# Project Submittal Interim Form

**Project Name:** \* NC 211 Brunswick County, R-5021

USACE Action ID: SAW-2007-03647-010

Modification/Reissuance Request as GP 50

PERMIT DRAWING  
SHEET 29 OF 95

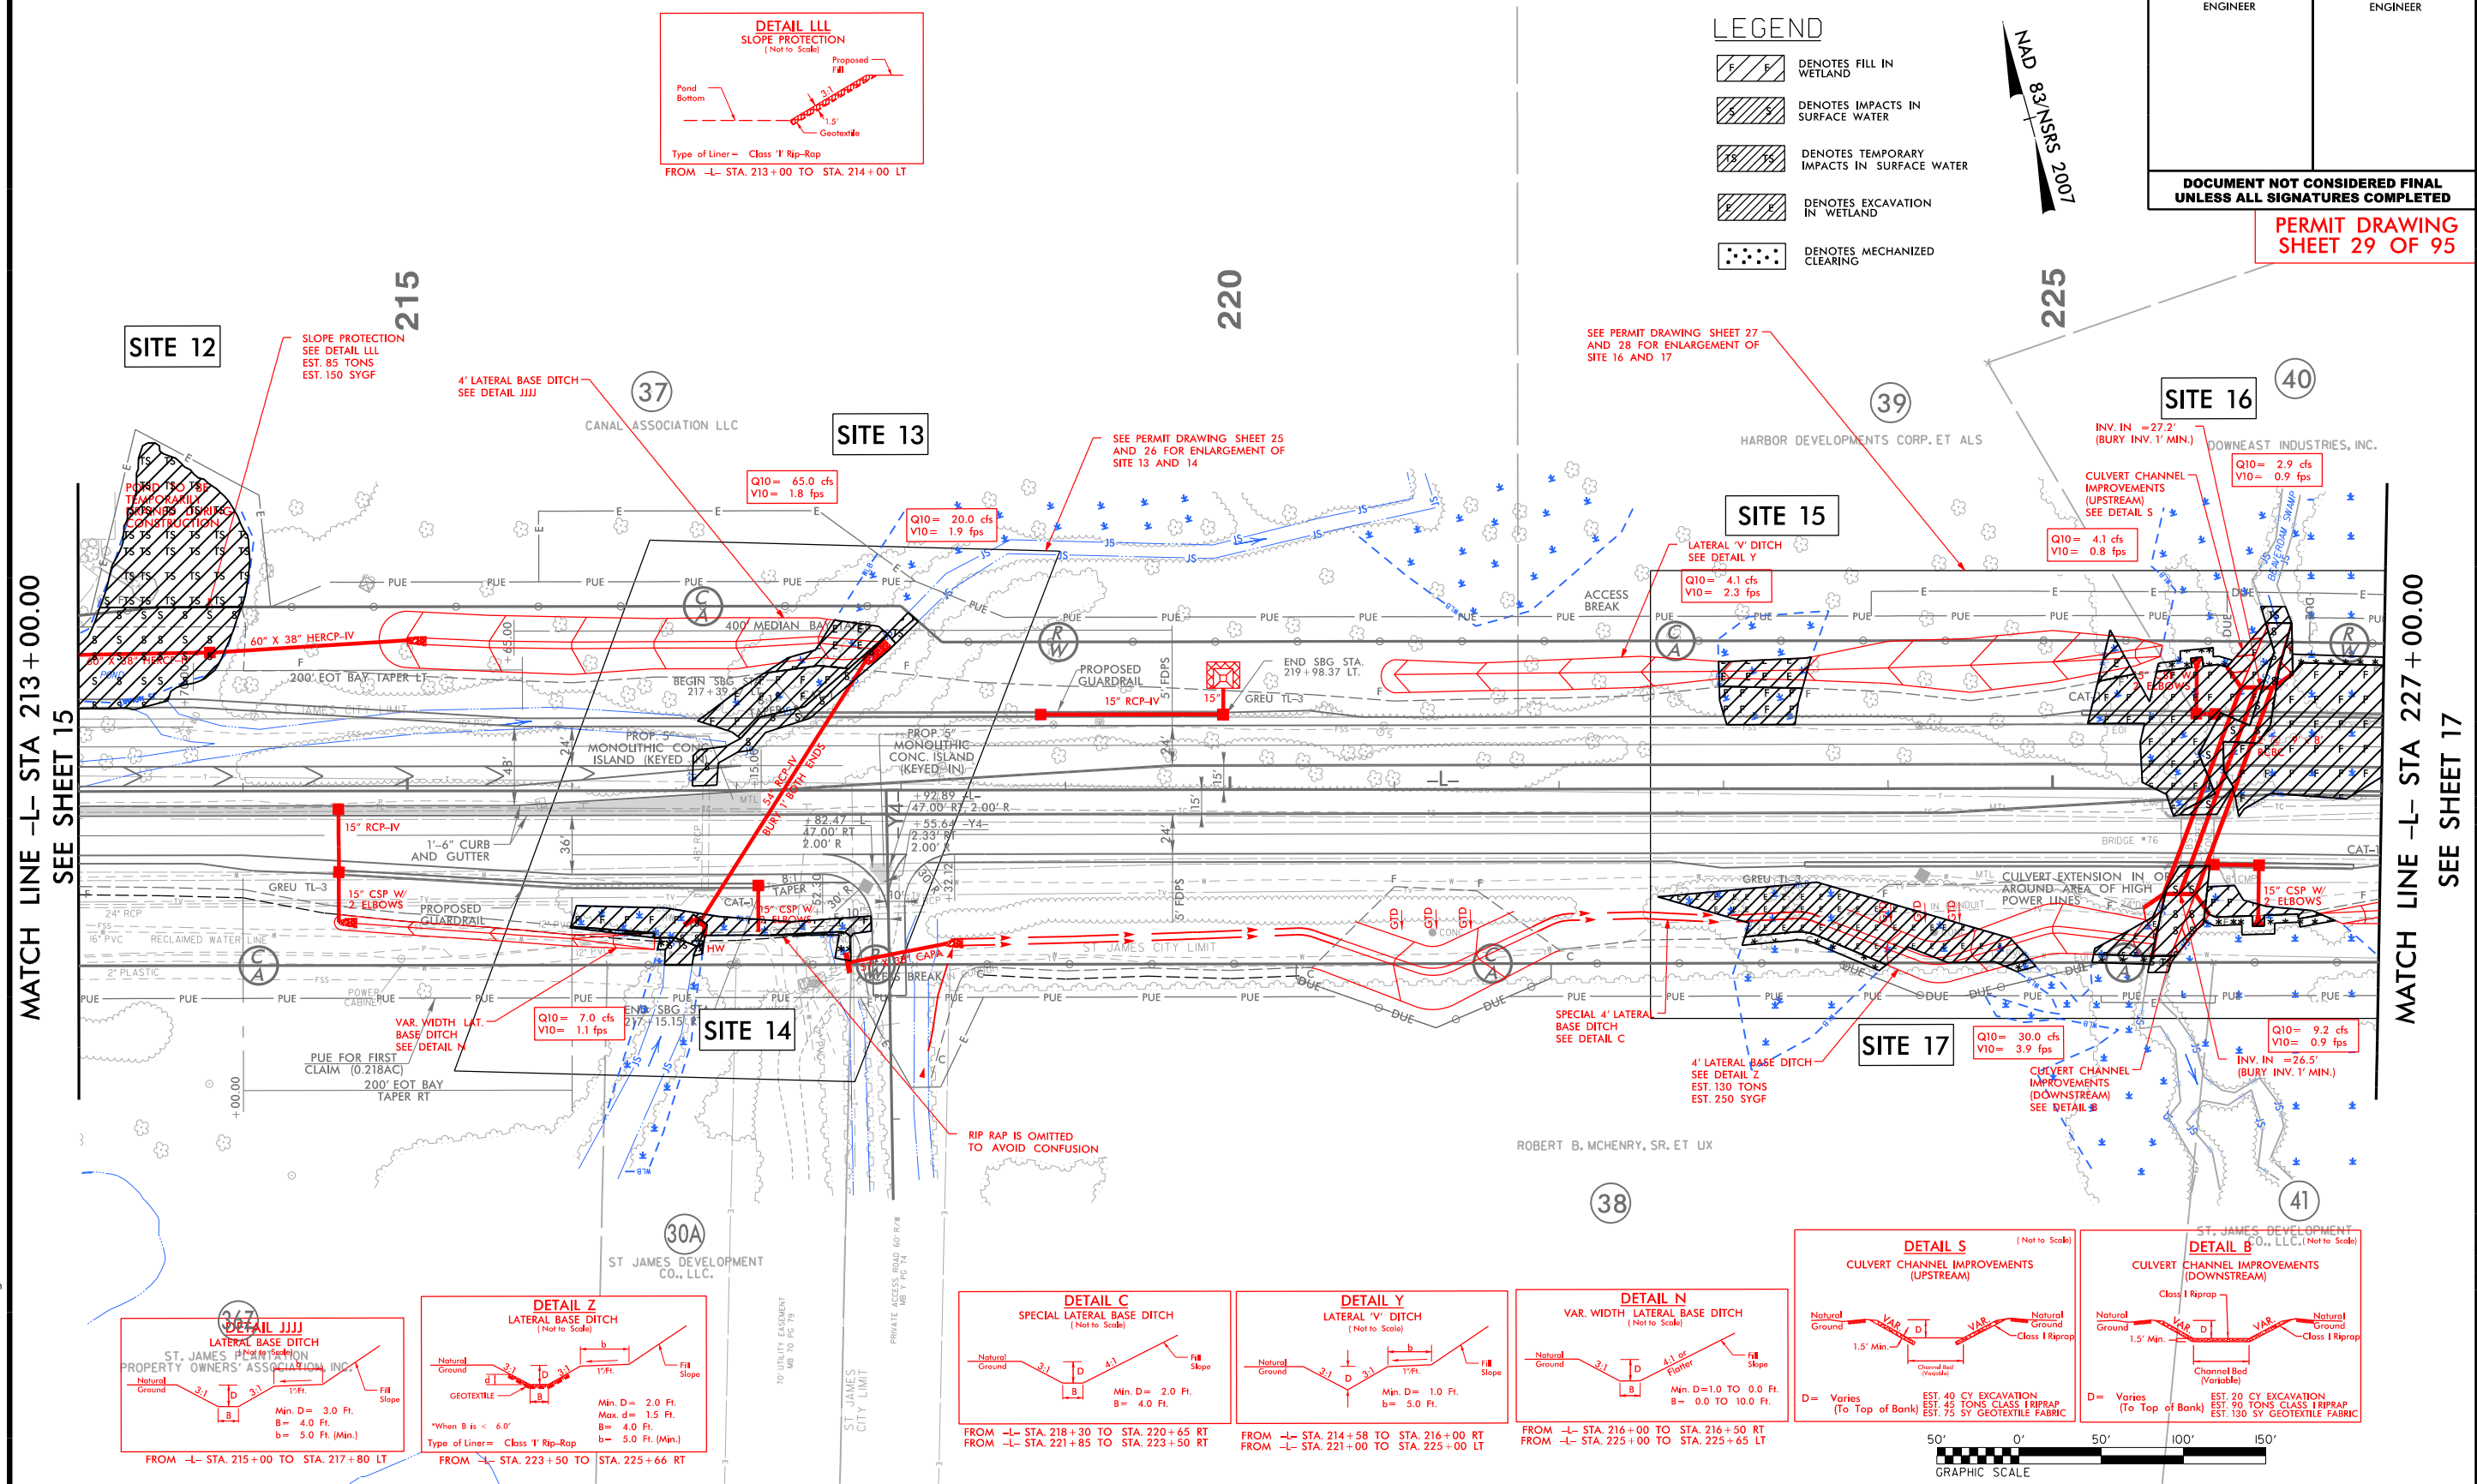
The project plans have been revised from the original permit. These revisions incorporate 5 ft of mechanized clearing (MC) on the backslope of the 4 ft base ditch for constructability purposes. The additional MC added 0.09 acres of permanent impact to the project so a revised acceptance letter from DMS is required. Ten of the project permit drawings have been revised to reflect these changes: 29, 30, 35, 36, 47, 48, 52, 53, 94 and 95, of 95.
